# PLANNING AND ZONING BOARD MEETING

# NEW BUSINESS

**75 Holden Ave.**

**RE: 75 Holden Ave – Boise Cascade Plan Review  
CPH project number E7601**

SHT NO.  
**C2.0**

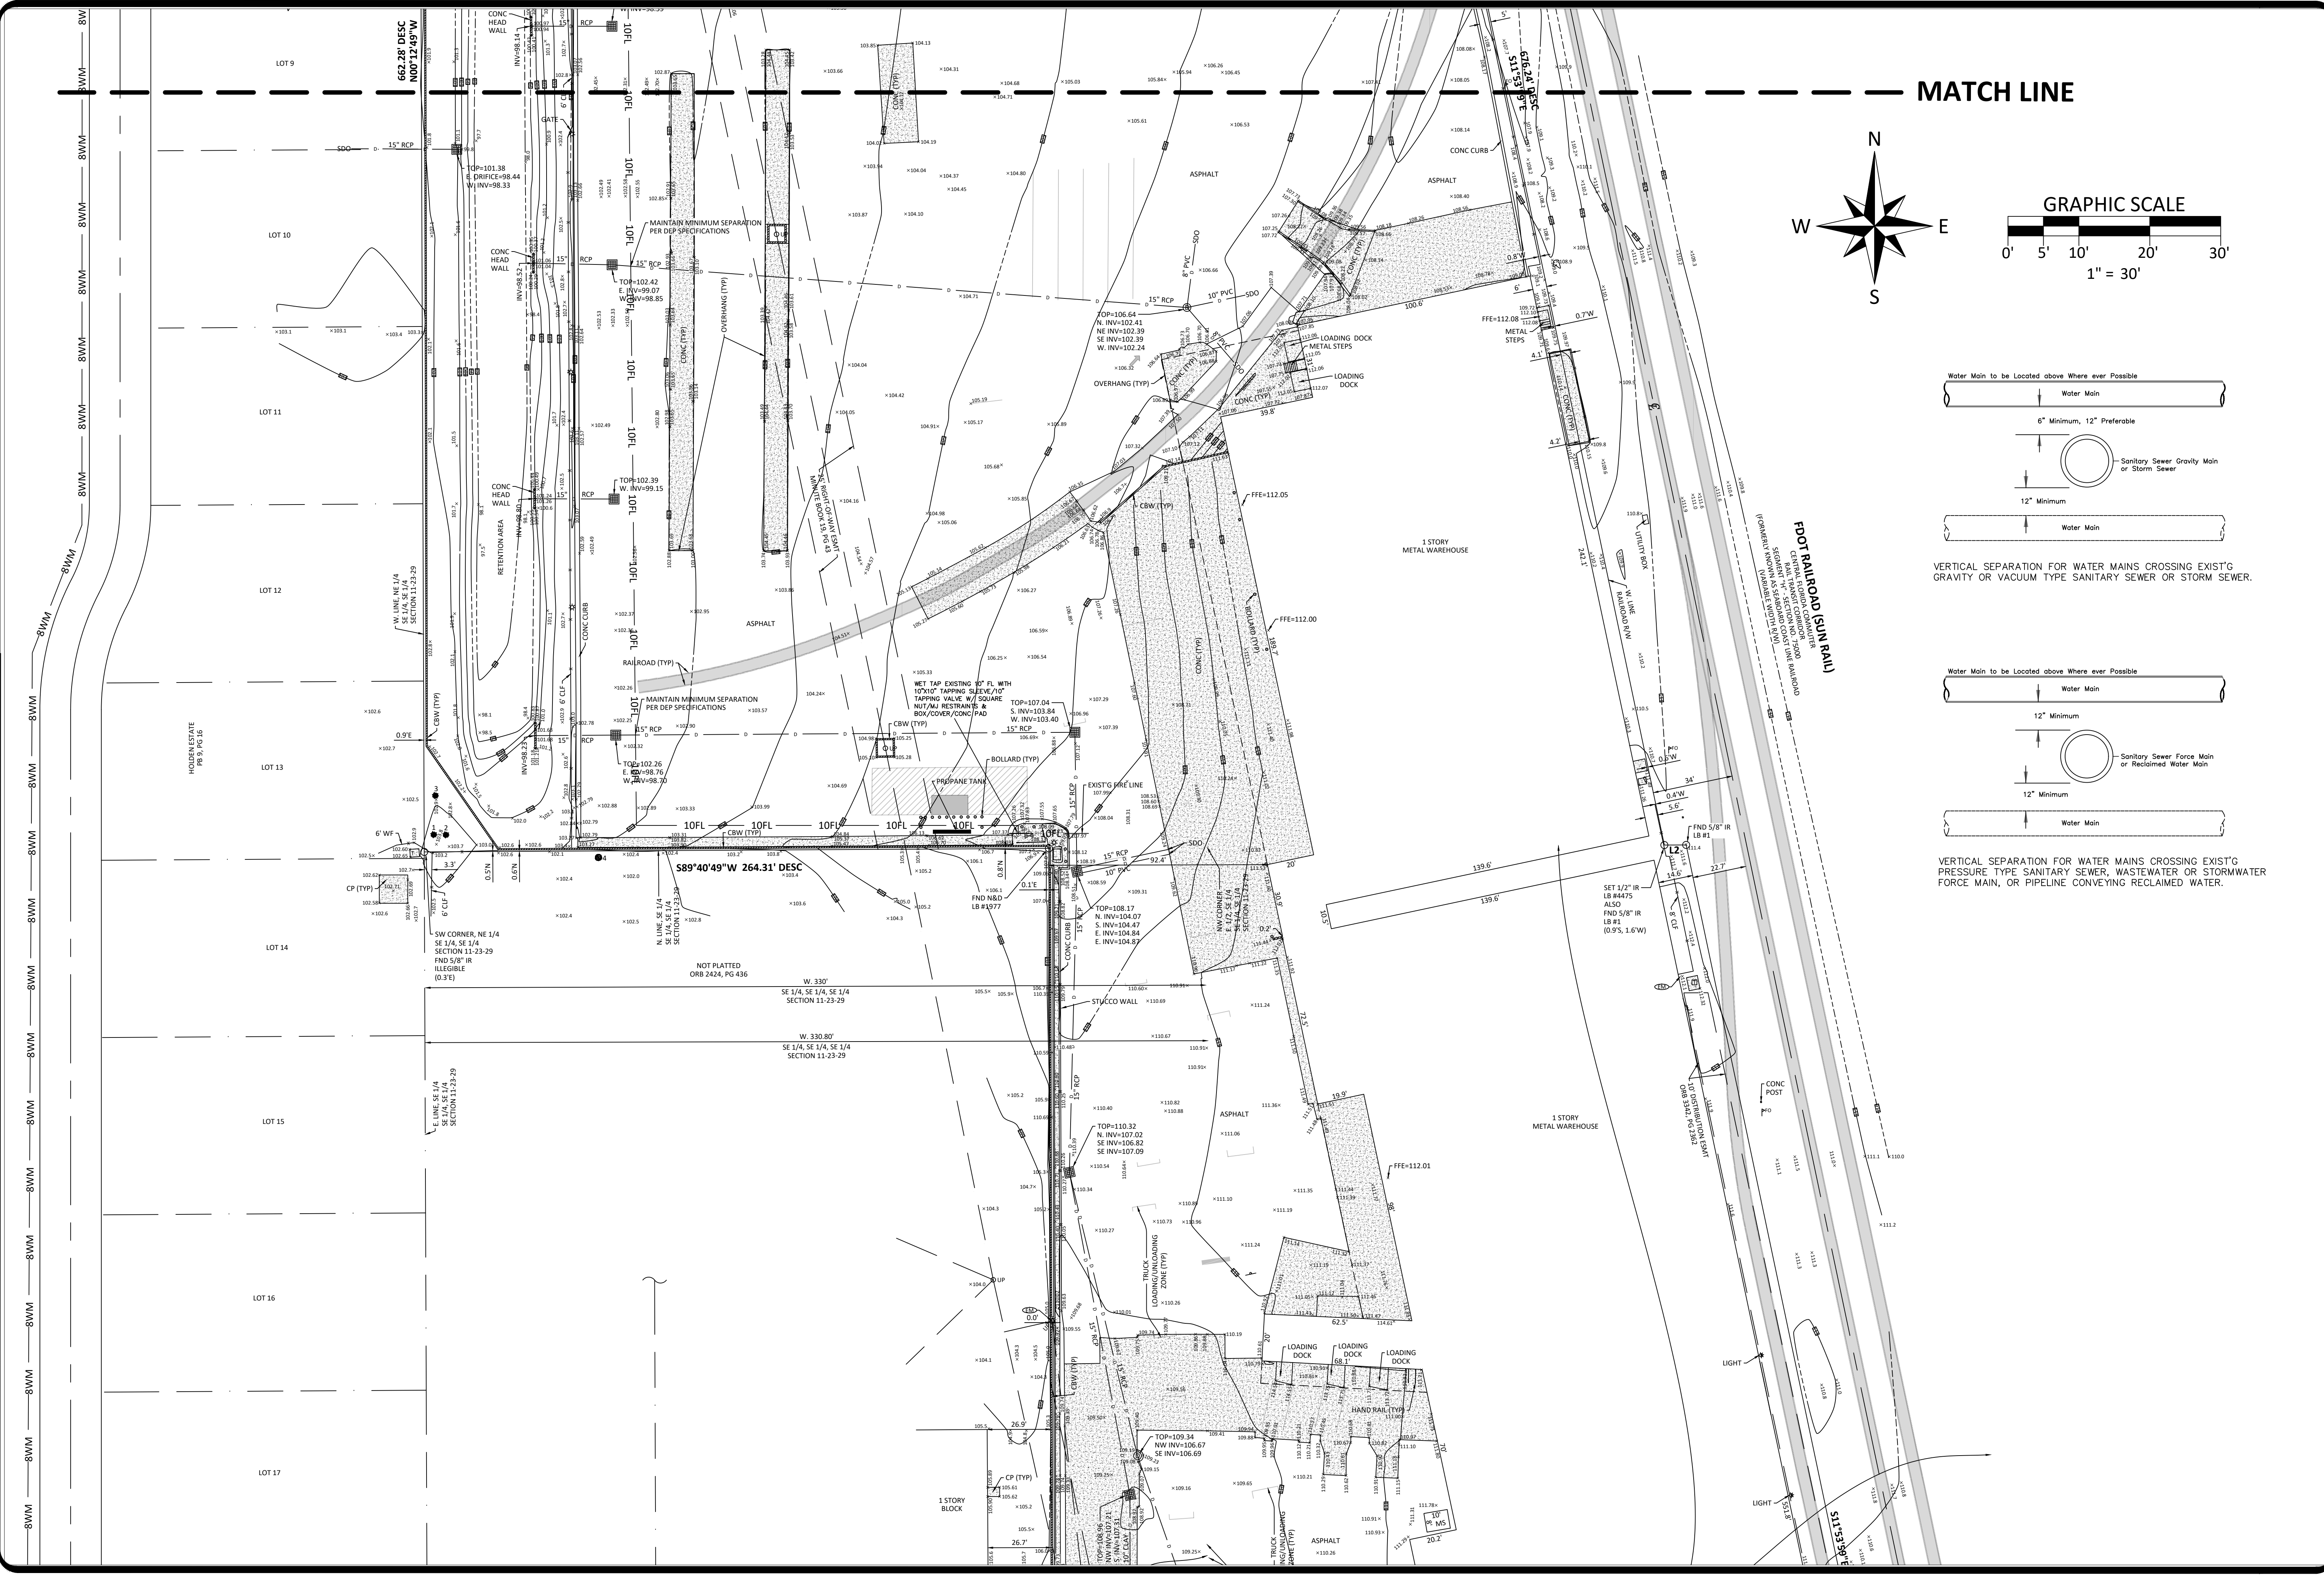
We had specific comments for the civil plans, sheets C1.0 to C4.0. Specifically, our concerns are with the ADA parking, signage and striping. We reviewed the response letter and the updated plan sheet, C4.0, to verify if all our comments have been addressed. It appears all our past comments have been addressed.

The plan sheet now has spot elevations on each end of the proposed ADA parking spaces. Per ADA requirements, no parking space may be allowed to slope greater than 2.0 percent in any direction, linear or horizontal. The elevations provided on the plans indicate the slope is equal or less than the required 2.0 percent slope. We do not have any objections to the grades provided. The final construction will be measured and a level use to verify the slopes after construction to verify if the spaces meet ADA requirements.

“Do Not Enter” signs have been added to the plans, on both sides of the exit drive. We do not have any objections.

Informational comment - Orange County Fire Department (OCFD) will need to review and comment on the existing layout for emergency access. They may require access along the front of the building. If so, the parking will need to be restriped to accommodate OCFD. At a minimum, the City will require a letter from OCFD approving the layout. This can be a condition of approval.

Notes have been added to the plans stating to meet minimum separation per DEP specifications. This will need to be as-built and shown on the record drawings once constructed.
